Tuesday, May 11, 2021
Medway Planning and Economic Development Board
155 Village Street
Medway, MA 02053

SALMON/WILLOWS ARCPUD FIELD CHANGE:

PUBLIC BRIEFING - BOUNDARY LANE PRELIMINARY SUBDIVISION PLAN:

MEDWAY PLACE SITE PLACE SITE PLAN:

**PRELIMINARY SUBDIVISION PLAN
OF
BOUNDARY LANE
IN
MEDWAY, MASS.**

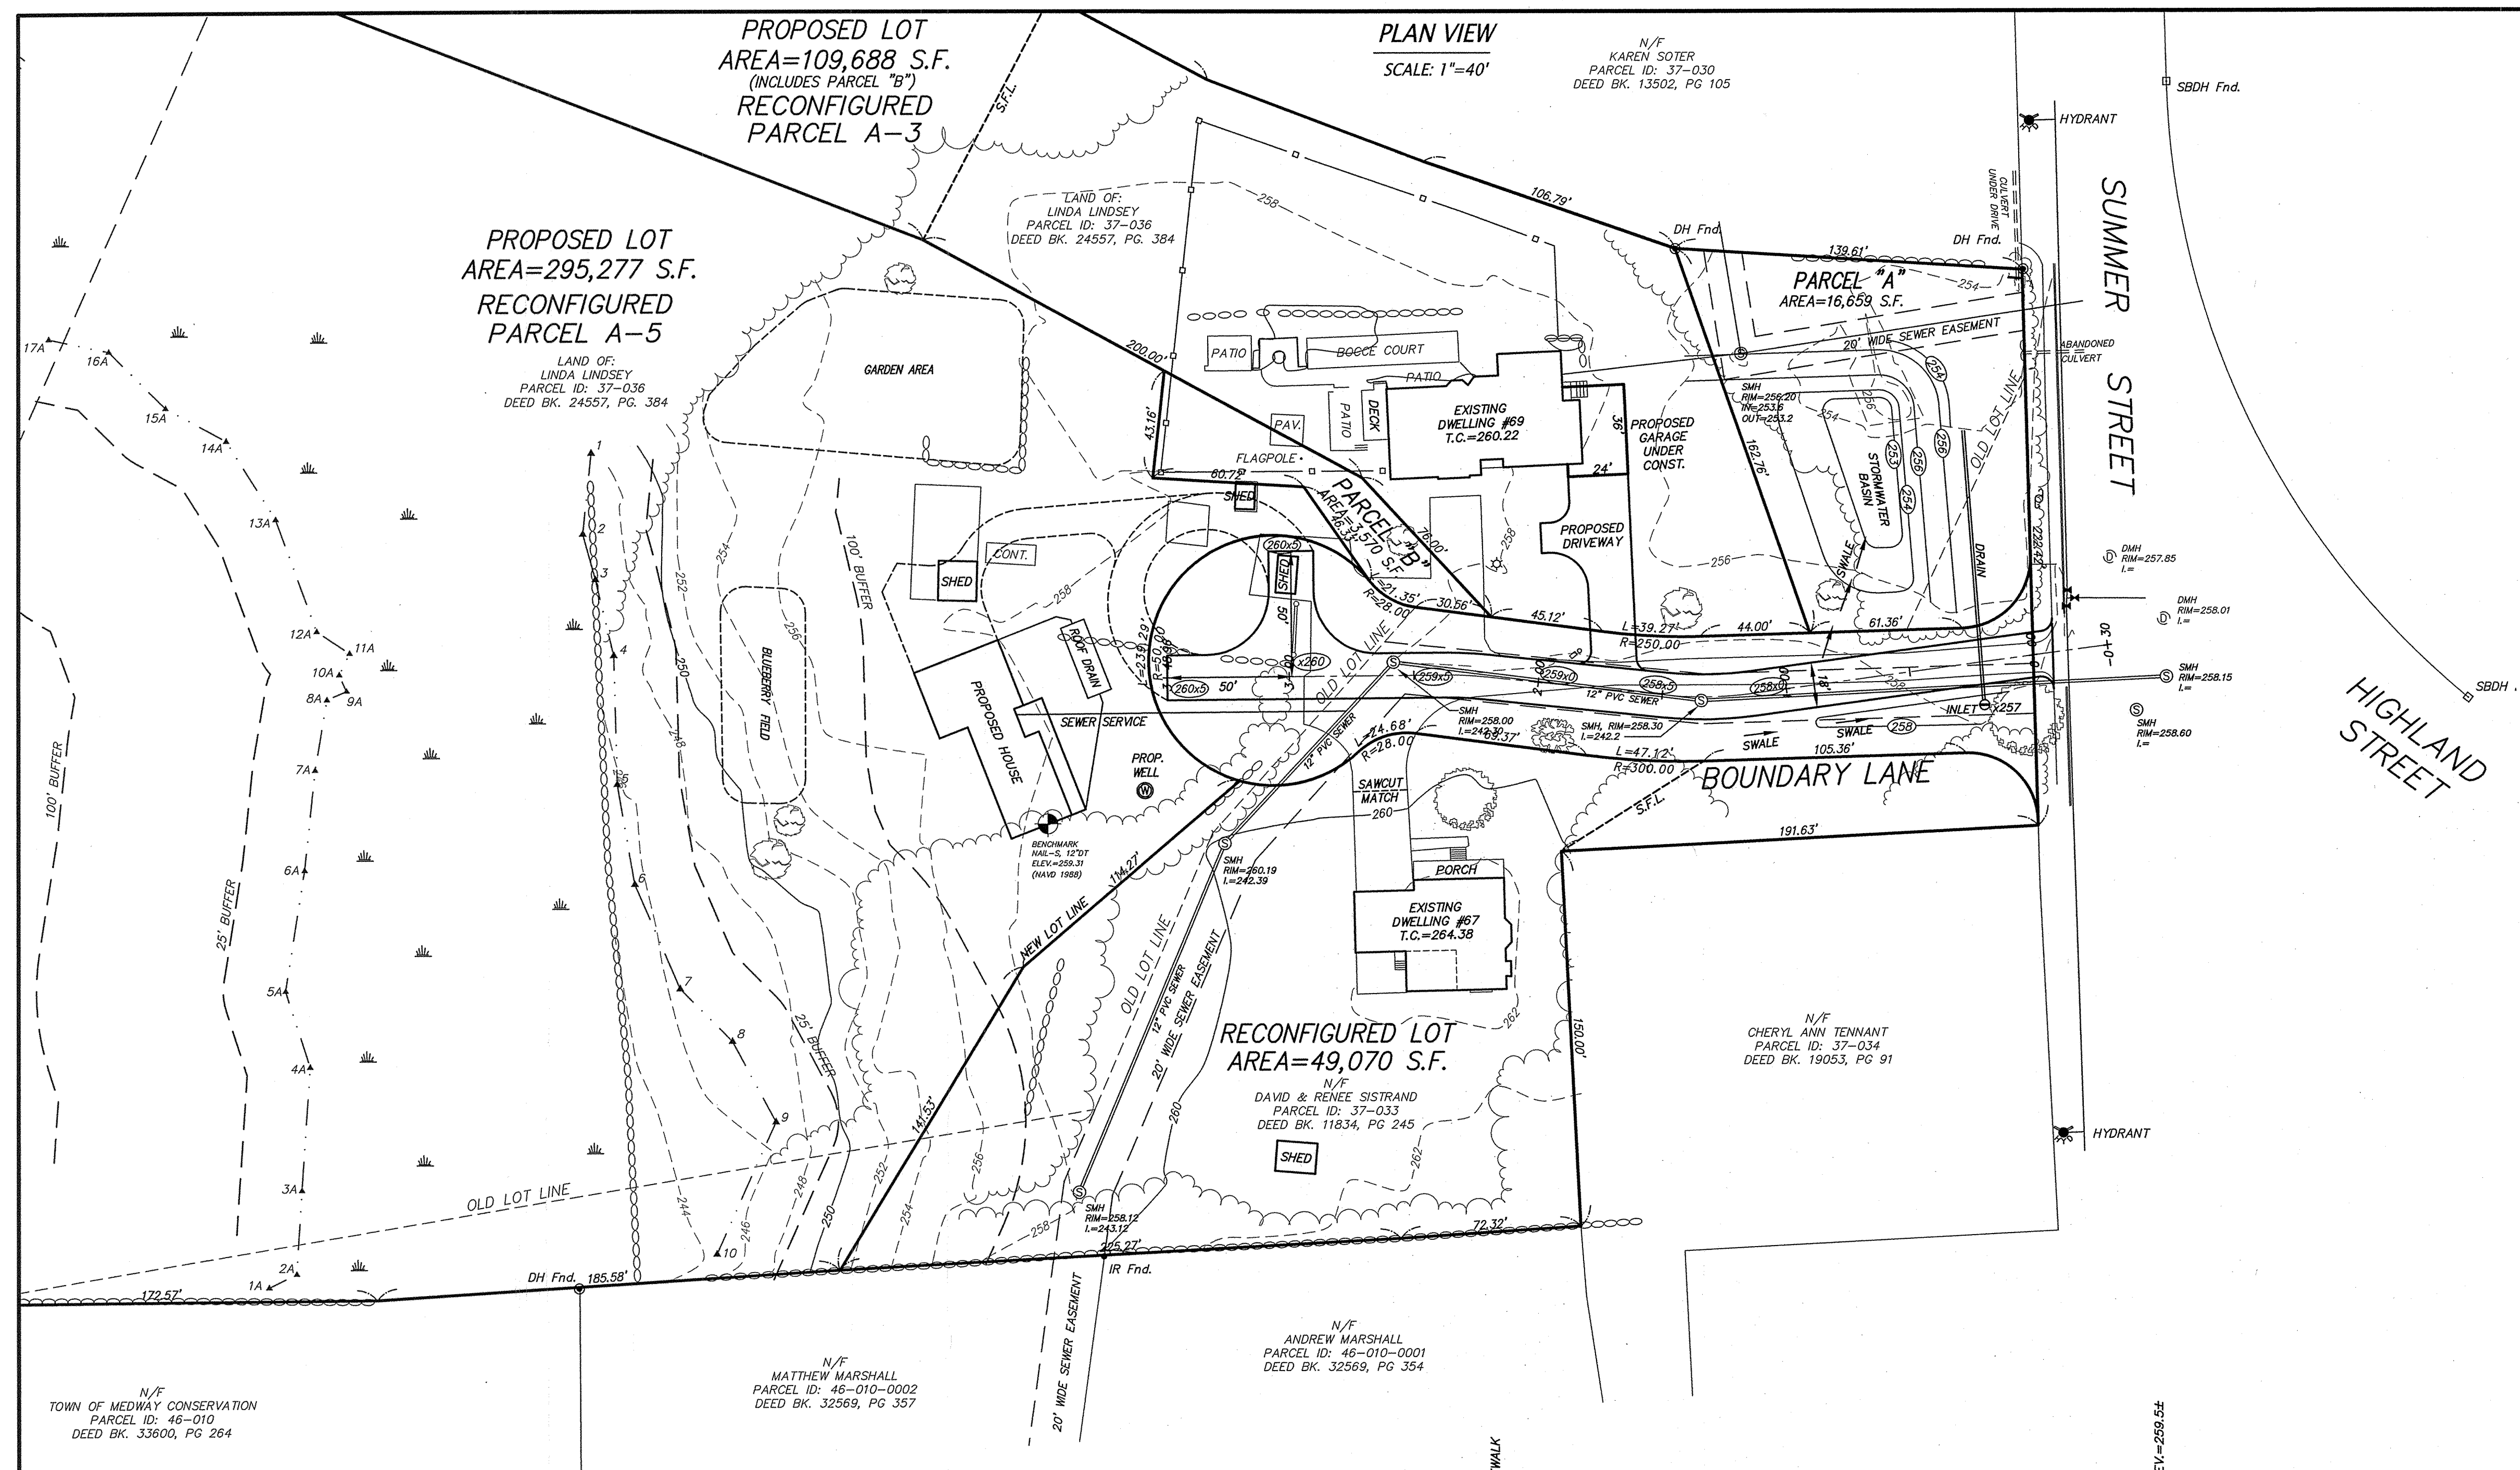
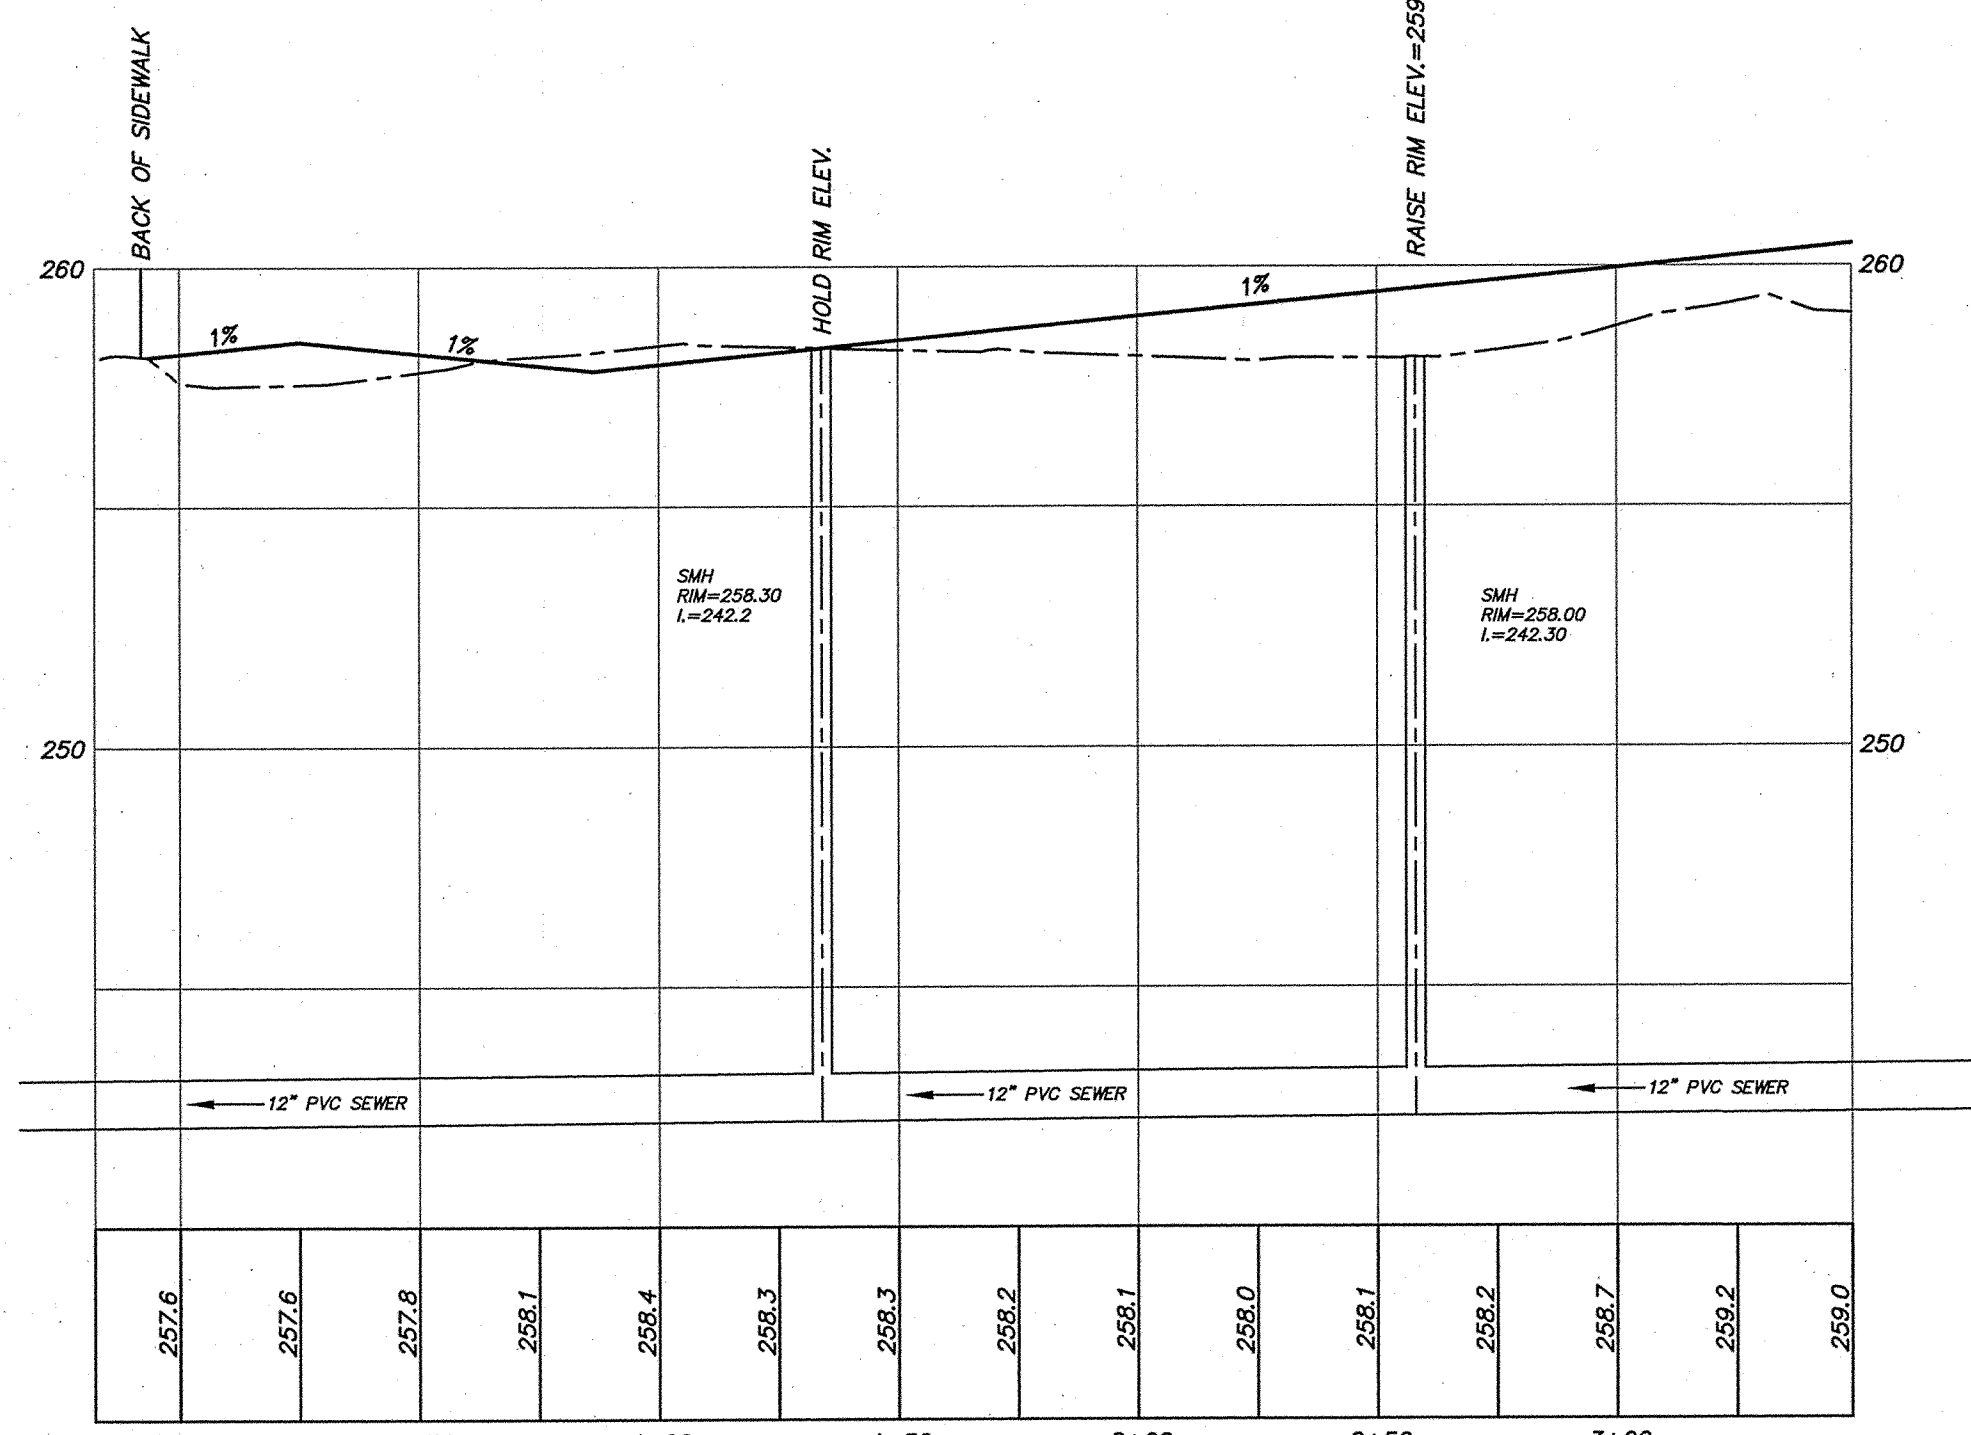
- Is the noted basin intended to infiltrate? Has there been soil testing done?
- There should be granite curbing at the roadway roundings at Summer Street.
- There needs to be erosion control at the pipe outlet.
- The plans should be colored due to the amount of detail. It is confusing to read.

I agree. I have a huge problem with this plan. There is a wetland where the stormwater basin is proposed and im not sure how close the road comes to the wetland (within 25')??? Anyway, I agree I have many, many questions. I will formalize this. I guess I am concerned that no one even looked at the site prior to its design. I was asked by BOH to review the new well and reviewed the wetland line along the western portion of the property. Even if the wetland is isolated it could never be a stormwater basin it will not meet the recharge requirements at all.

I will send comments but this plan is not feasible to me as designed, since the stormwater management standards cannot be met. I recommend that a wetland scientist review and delineated all wetlands, then start locating areas for stormwater and do test pits!!! But the first step is for the ENGINEER TO VISIT THE SITE.

The applicant responded to the consultant by explaining that they will provide turning radius template and this will be put on the plan. There will also be inclusion of some street trees. The intention of the applicant is to have Parcel A owned by the owner of 69 Summer Street, but that detail needs to be finalized. There will need to be a Homeowner's Association established for maintenance of the permanent private road and drainage. The street name will need to be approved by the Street Naming Committee. There was a question if there will need to be a hydrant. This needs to be verified in a letter from the Fire Chief.
